Synopsis

Application Request: Consideration and action on preliminary approval of Kastle Acres, an 11-lot subdivision.
Type of Decision: Administrative
Agenda Date: Tuesday, April 14, 2020
Applicant: Lane Kap, Owner; Chris Cave, Representative
File Number: LVK122019

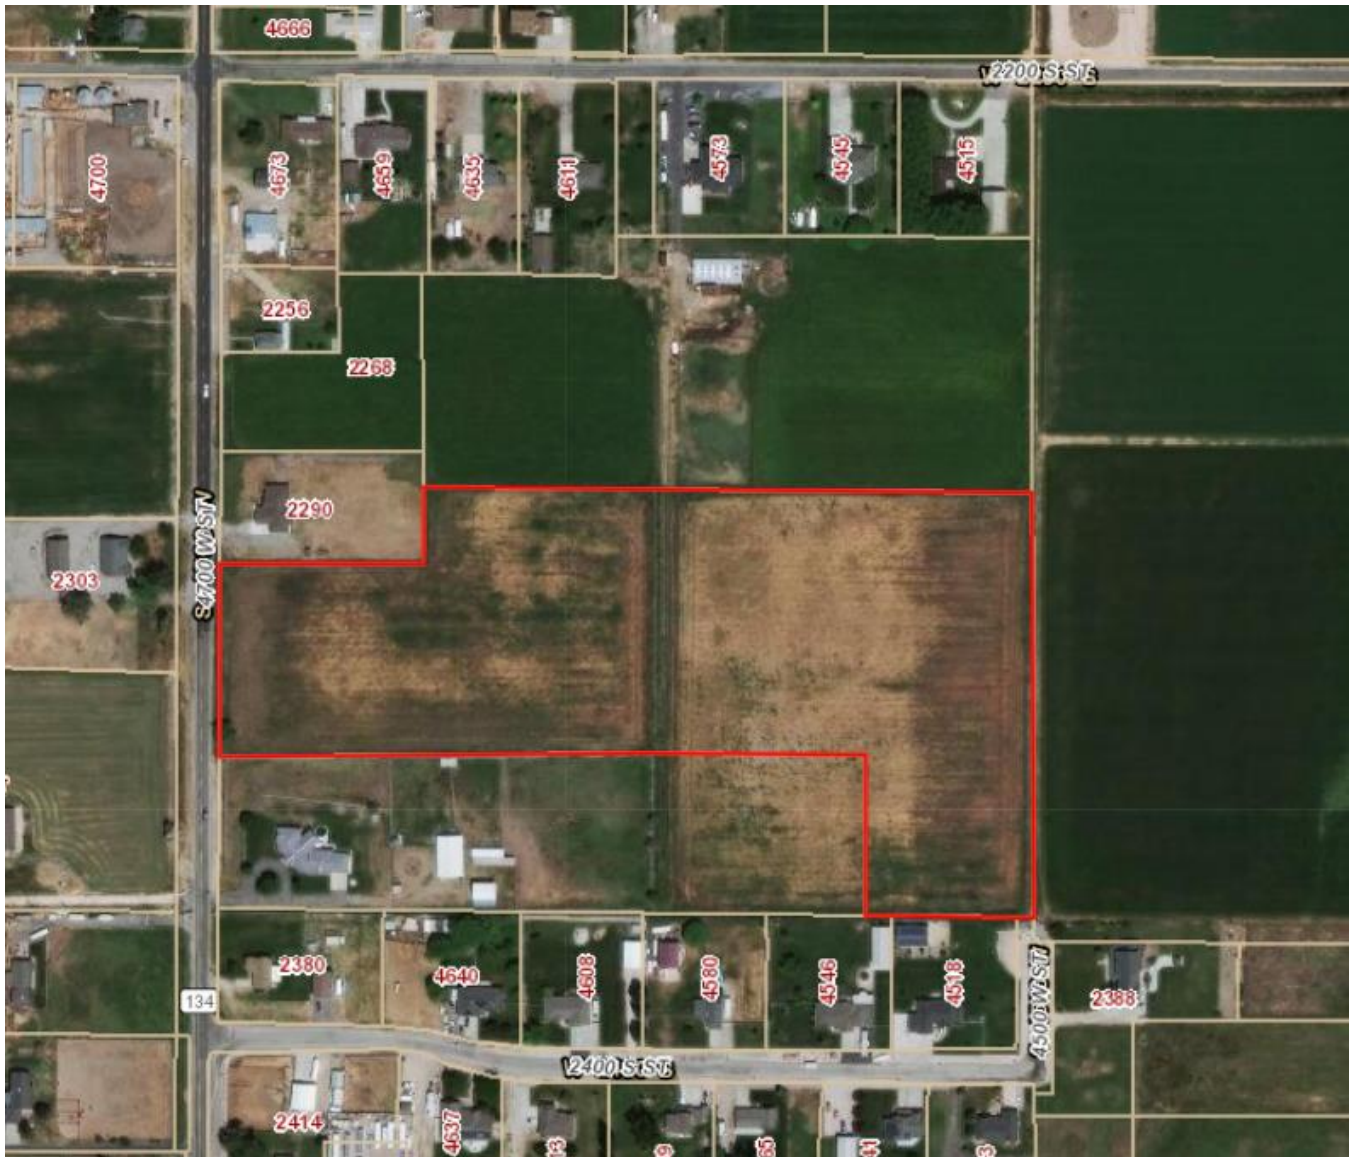
The submitted preliminary plat depicts sidewalks being provided on both sides of the new right-of-way. However a sidewalk will need to be depicted along 4700 W Street, or a UDOT waiver letter must be provided, prior to scheduling for final approval.

The proposed subdivision will create one new public street along with a turnaround easement to provide primary access for all 11 lots. The development will also dedicate approximately 5 feet of ROW along its frontage of 4700 West to complete the full 50' of ROW required along the western half of 4700 West. Prior to scheduling for final approval, this public street will require an access approval letter from UDOT.

Finally, the development will dedicate 19 feet of right of way along the eastern property boundary in anticipation of future development on adjacent properties. This 19 feet of dedicated ROW represents the half-width portion of ROW that falls on the subject property to allow for the future extension of 4500 West to the North. The property owner to the East (Lena M Jusko Trustee) was consulted regarding the alignment of this ROW dedication to determine if they would be interested in developing alternative scenarios that could better accommodate their property for future development. This property owner indicated that they do not intend to develop their property and thereby have no desire to negotiate alternative alignment scenarios.

For the time being, this 19 feet of dedicated ROW will be improved as a pathway and bollards will be required on either end to ensure it is not used as a substandard street.
